Bates West Flooring Replacement Project

University of South Carolina
Project Number: 50003340-2
Project advertised: March 14, 2019

ADDENDUM NO.2

April 2, 2019:

ID2.1
1ST FL
FINISH PLAN

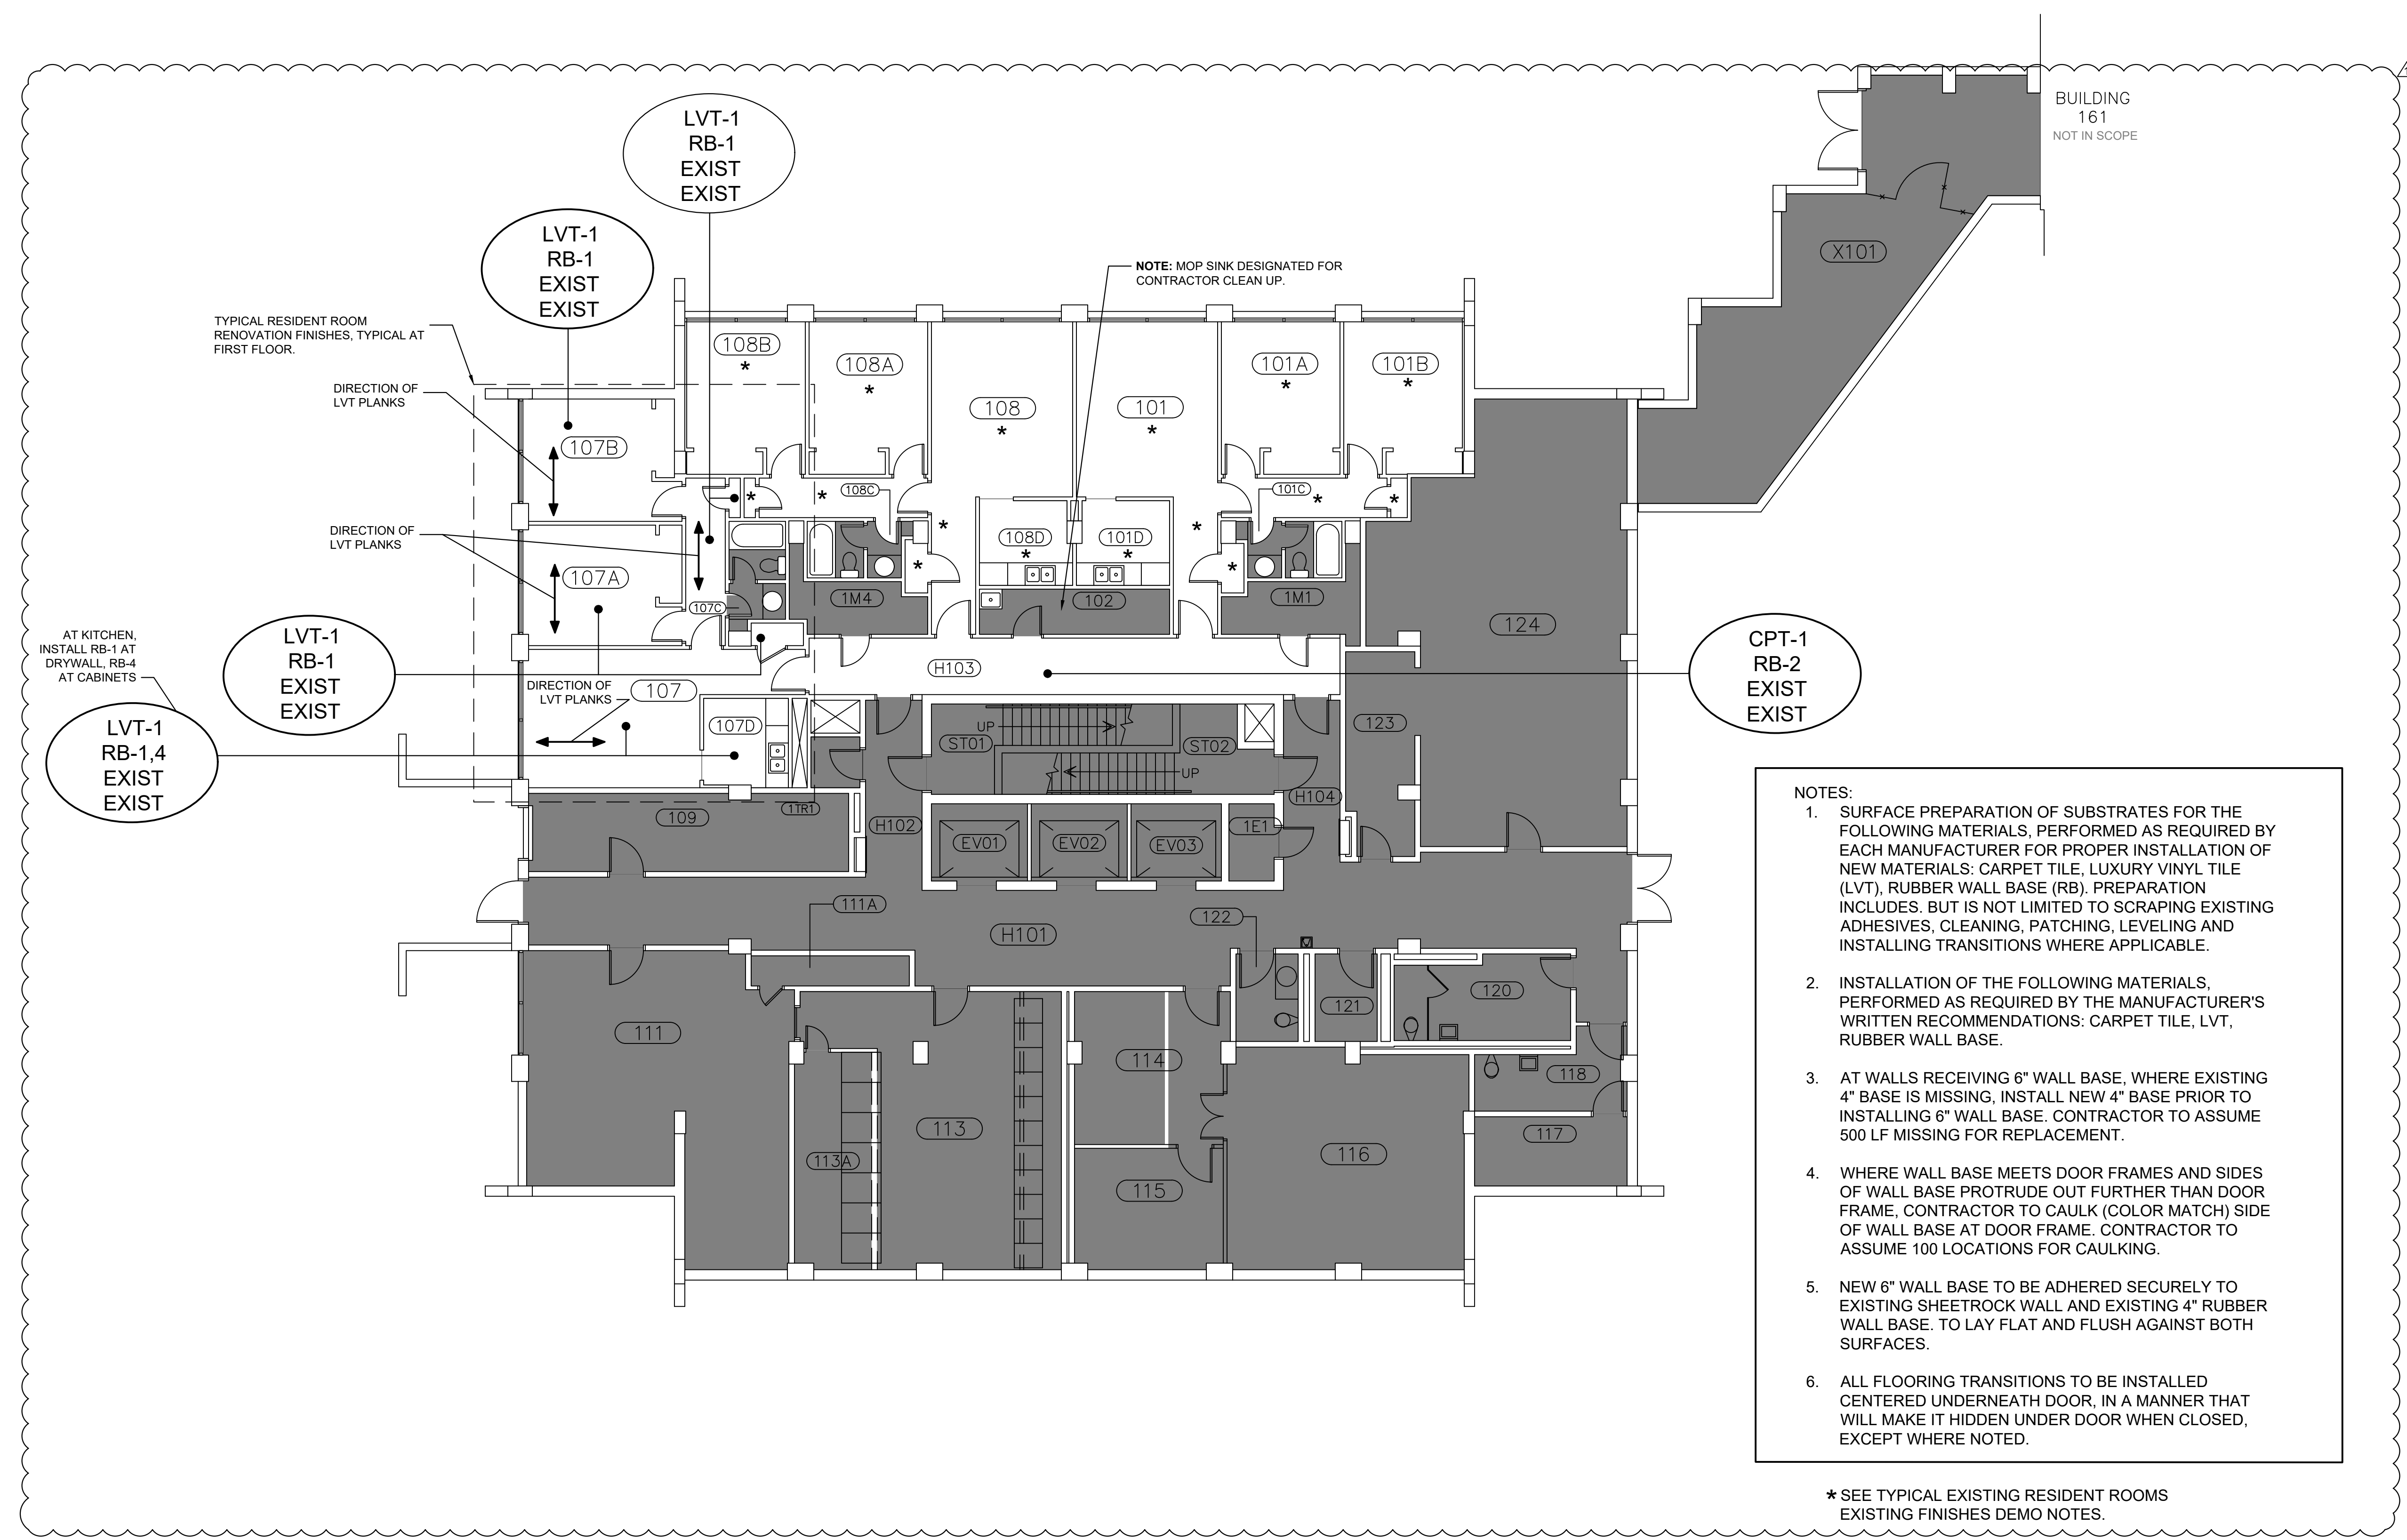
- a. Refer to Specifications section “PART 2 – PRODUCTS” for Basis of Design specifications and two “or equals” per each finish selection.
 - b. Refer to Project Manual, “AIA Document A701 – 1997, Instructions to Bidders” Section: “3.3 SUBSTITUTIONS” for requirements on requesting substitutions.
8. Door thresholds where tile was meeting carpet in the downstairs hallway, should we carry that transition to the center of the door, or leave as is and but LVT up against tile as the carpet is?

Response: Refer to revised Drawings, ID2.1, ID2.2, ID2.3, notes section for details.

2. INSTALLATION OF THE FOLLOWING MATERIALS, PERFORMED AS REQUIRED BY THE MANUFACTURER'S WRITTEN RECOMMENDATIONS: CARPET TILE, LVT, RUBBER WALL BASE.
 3. AT WALLS RECEIVING 6" WALL BASE, WHERE EXISTING 4" BASE IS MISSING, INSTALL NEW 4" BASE PRIOR TO INSTALLING 6" WALL BASE. CONTRACTOR TO ASSUME 500 LF MISSING FOR REPLACEMENT.

4. WHERE WALL BASE MEETS DOOR FRAMES AND SIDES OF WALL BASE PROTRUDE OUT FURTHER THAN DOOR FRAME, CONTRACTOR TO CAULK (COLOR MATCH) SIDE OF WALL BASE AT DOOR FRAME. CONTRACTOR TO ASSUME 100 LOCATIONS FOR CAULKING.

5. NEW 6" WALL BASE TO BE ADHERED SECURELY TO EXISTING SHEETROCK WALL AND EXISTING 4" RUBBER WALL BASE. TO LAY FLAT AND FLUSH AGAINST BOTH SURFACES.
 6. ALL FLOORING TRANSITIONS TO BE INSTALLED CENTERED UNDERNEATH DOOR, IN A MANNER THAT WILL MAKE IT HIDDEN UNDER DOOR WHEN CLOSED, EXCEPT WHERE NOTED.

ID2.3
TYPICAL
RESIDENTIAL
FLOOR FINISH PLAN
(FLOORS 3-14)

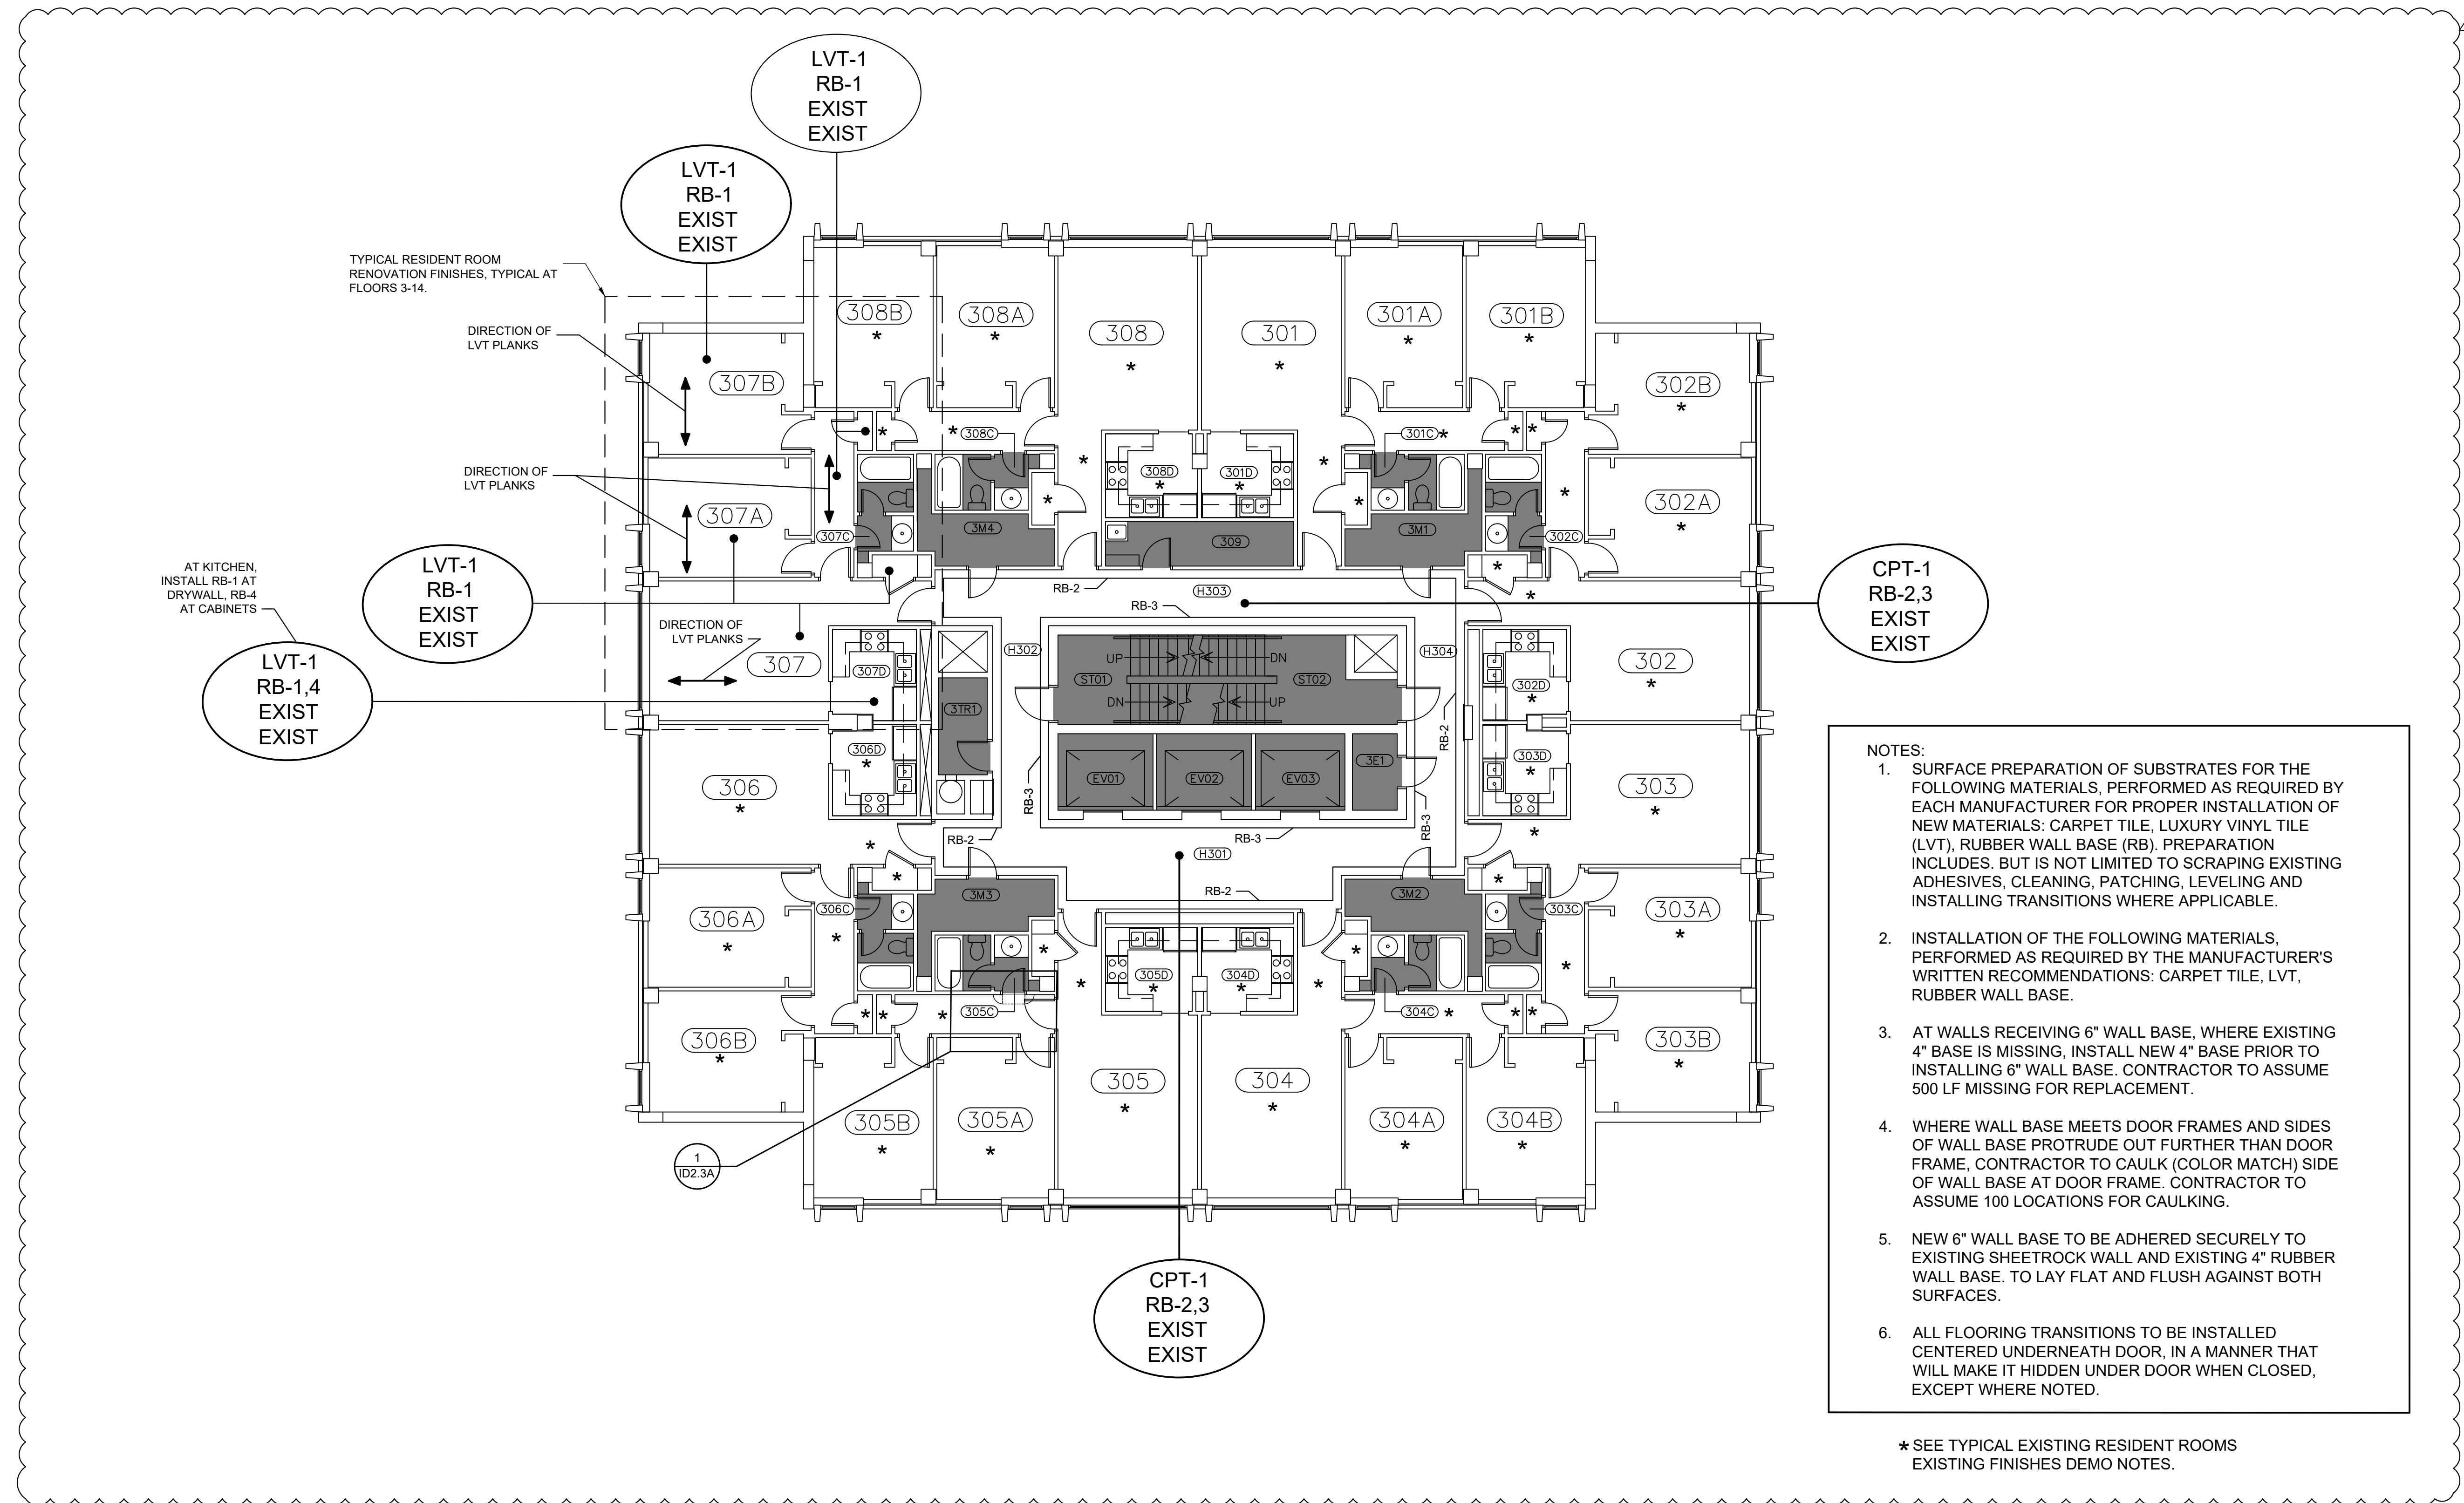
2. The transition area going into the bathroom doesn't allow enough room to slope it in the hallway to level off the way the drawings show. If we are still to raise the flooring to meet the tapered section of the marble threshold, what is going to be an acceptable hump in the floor in the hallway?

6. When covering existing 4" base in hallways with 6" base it creates a void in the wall at the top. What will be acceptable on this?

Response: Refer to revised drawings ID2.3, ID2.3A for details.

Response: Refer to revised drawing *ID2.3* and *Finish Schedule* on *T1.1* for revised scope.
